**6 Ordinary Business**  
**6.1 Town Planning Reports**

## **6.1.1 Amendment C238card Glismann Road - Review Panel Recommendations and Adopt Amendment**

A Planning Panel was held on 4 May 2021 to 7 May 2021, with the final day on the 11 October 2021. The Panel report was received on 4 January 2022 with a Panel Report re-submitted on 25 January 2022, with minor typographical changes.

Figure 6: Section of Development Plan (masterplan) showing road connection to 11 Mahon Avenue

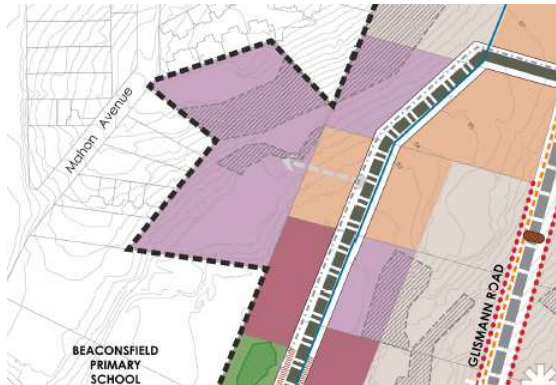
An implication of the removal of 11 Mahon Avenue from the Amendment is the treatment of the *"Road connection"* in the Development Plan (masterplan) exhibited in DPO19, shown in Figure 6.

**Figure 8: Optimised Transport Network proposed by Mr Maina**

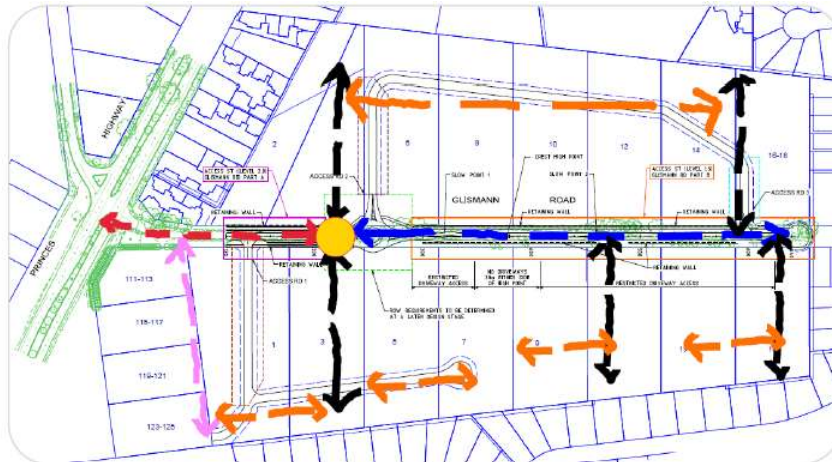
Mr Maina of Impact Traffic Engineering gave evidence on behalf of the Glismann Rd residents. He focused on the lack of permeability and resilience in the proposed road network, particularly east of Glismann Road. He submitted an alternative design (see proposed ‘optimised transport network’ Figure 8), with the roundabout on Glismann Road relocated to the west by about 30 to 50 metres, and the following changes east of Glismann Road:

- an access lane a direct connection to Glismann Road to the rear of the lots that have a frontage to Princes Highway
- short east - west local road cul-de-sacs to provide access to lots that are landlocked.

**Figure 10: Detail of Traffic Impact Assessment design of roundabout**

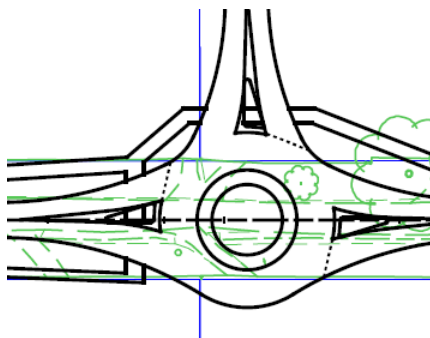
The Panel notes that the proposed footpath to the west of the roundabout in Glismann Road in the TIA encroaches on the property referred to in Submission 4.

**Figure 1: Glismann Road Development Plan**

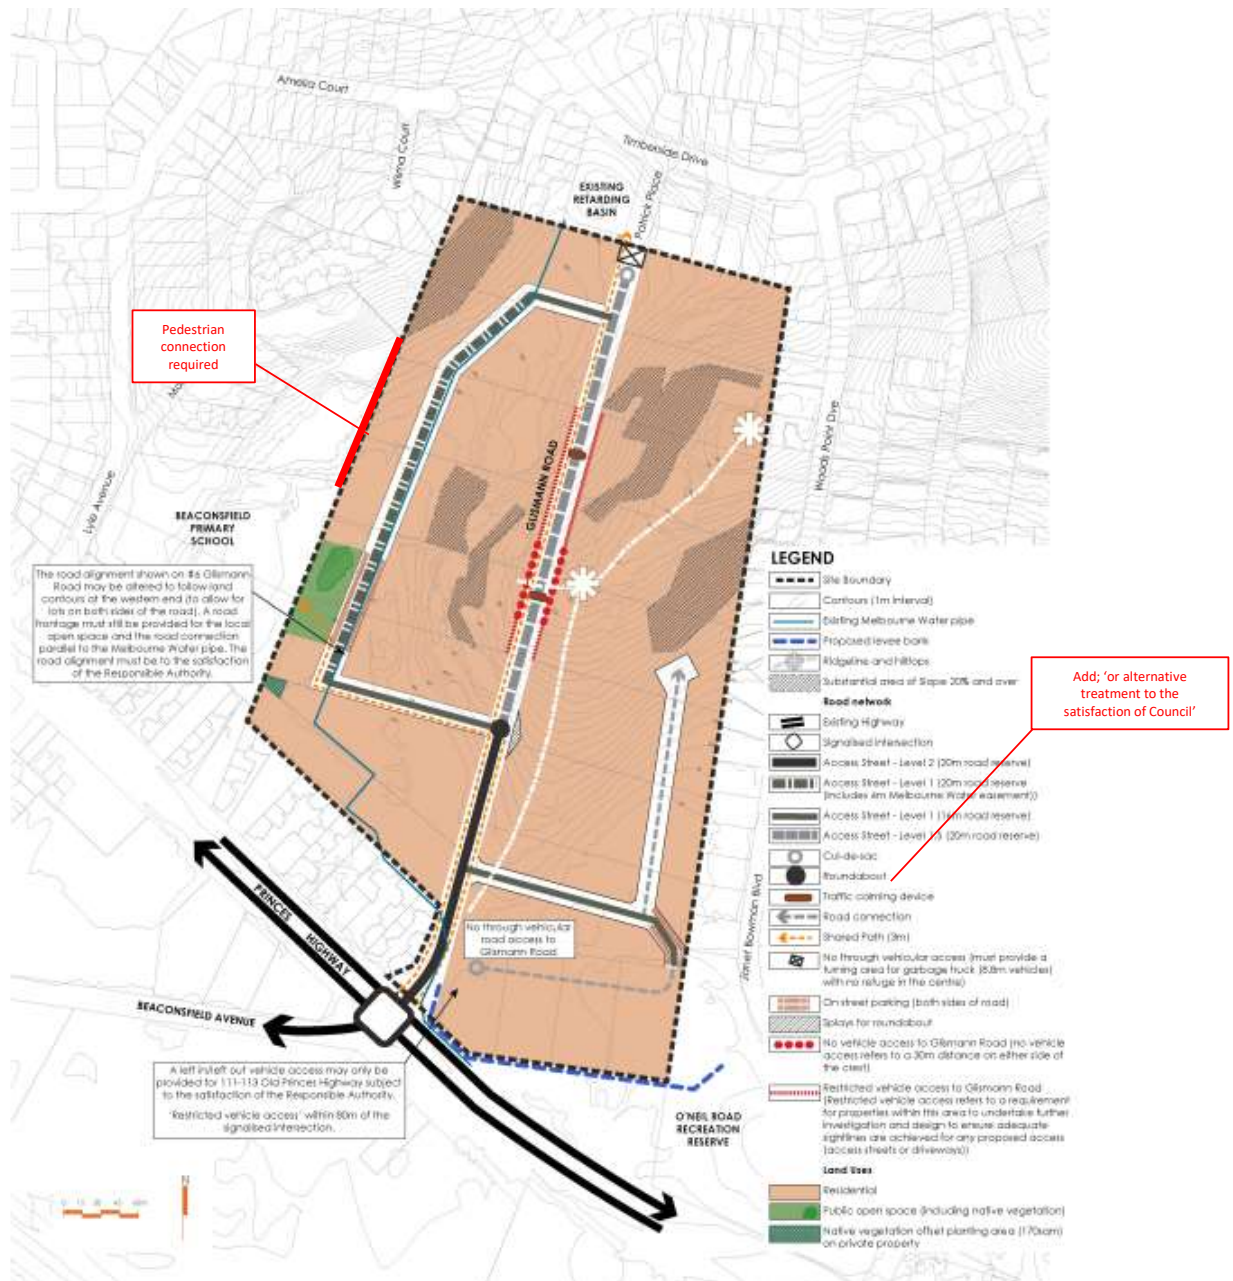
<a href="#">Cardinia Shire Council Closing Submission (11 October 2021)</a> Matters Addressed in Council's Closing Submission	Panel's response ( <a href="#">Panel Report</a> ) ✓ = Supported by the Panel ± = Supported by the Panel in part - changes recommended
C.1.5. Traffic management and internal road network	
<p><b>Roundabouts</b></p> <p>As outlined in C.1.3. Access arrangements for 111-113 Old Princes Highway, the first roundabout (as shown in exhibited DP019 Figure 1) performs multiple functions, one of which is to permit u-turn movements to occur (i.e. to enable access to any left-in/left-out intersection to 111-113 Old Princes Highway).</p> <p>Should 111-113 Old Princes Highway not require the left in / left-out access onto Glismann Road, Council could consider an alternative traffic management solution in place of the roundabout.</p>	<p>✓</p> <ul style="list-style-type: none"> <li>Panel Recommendation 1 - Apply the changes documented by Council in its closing submission (and presented in Appendix C of this report for Development Plan Overlay, Schedule 19).</li> <li>Panel Recommendation 3d - In Development Plan Overlay Schedule 19, Schedule 1 in respect of the proposed roundabout in Glismann Road, provide for alternative treatments of the intersection.</li> <li>Panel Recommendation 4a - Update Glismann Road Residential Development – Traffic Impact Assessment Report (Trafficworks, June 2020) to, in respect of the proposed roundabout in Glismann Road, note that a reverse-priority controlled T-intersection in place of the proposed roundabout in Glismann Road may be appropriate.</li> </ul> <p><b>Council Closing Submission</b></p> <p><b>Figure 1 DP019 be modified</b> as follows:</p> <ul style="list-style-type: none"> <li>roundabout 2 be replaced with a standard T-intersection in this location</li> <li>roundabout 3 be replaced with an arrow to show possible road connection further north.</li> </ul>

<p><b>Legend accompanying Figure 1 DP019</b></p>	<p>✓</p> <ul style="list-style-type: none"> <li>Panel Recommendation 1 - Apply the changes documented by Council in its closing submission (and presented in Appendix C of this report for Development Plan Overlay, Schedule 19).</li> </ul> <p><b>Council Closing Submission</b></p> <p><b>DP019 be amended</b> so that the naming of the 'road network' of DP019 is consistent with the Trafficworks Traffic Impact Assessment.</p>

d. Sub dot point 12 to dot point 1 <i>Delete 11 Mahon Avenue</i>	<a href="#">11 Mahon Avenue removed from AmC238card.</a>	✓
8. Figure 1: Glismann Road Development Plan	<a href="#">See Attachment B 'Tracked changes' DPO19 (Version 3)</a>	✓  Panel additions: <ul style="list-style-type: none"> <li>• Pedestrian connection between Mahon Avenue and Glismann Road DP area.</li> <li>• Roundabout notation 'or alternative treatment to the satisfaction of Council'.</li> </ul>

Figure 1: Extract from GRDCP (Draft) (June 2020) (exhibited AmC238)

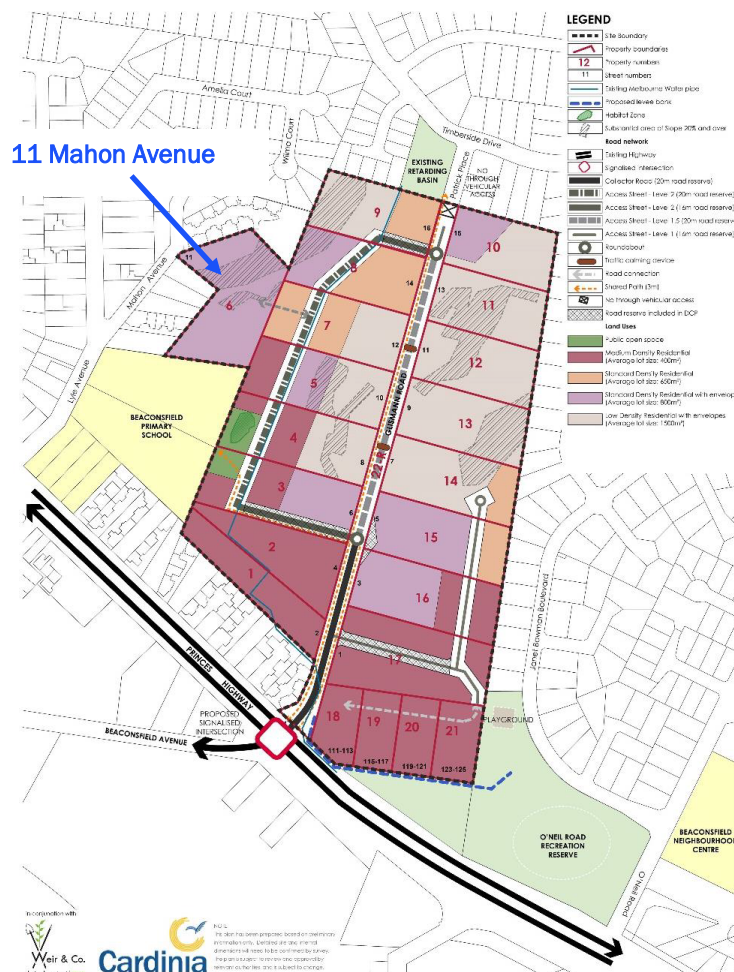
Development Plan Overlay (DPO19) will still be applied to 11 Mahon Avenue to facilitate a pedestrian link with 11 Mahon Avenue and the Glismann Road Development Plan area. No other components of the Development Plan Overlay apply to this site.

The Main Catchment Area (MCA) of the GRDCP (as exhibited), consisted of land identified in Figure 1 which affected 21 properties. 11 Mahon Avenue was identified as property #6. The total area of 11 Mahon Avenue is 1.31 ha.
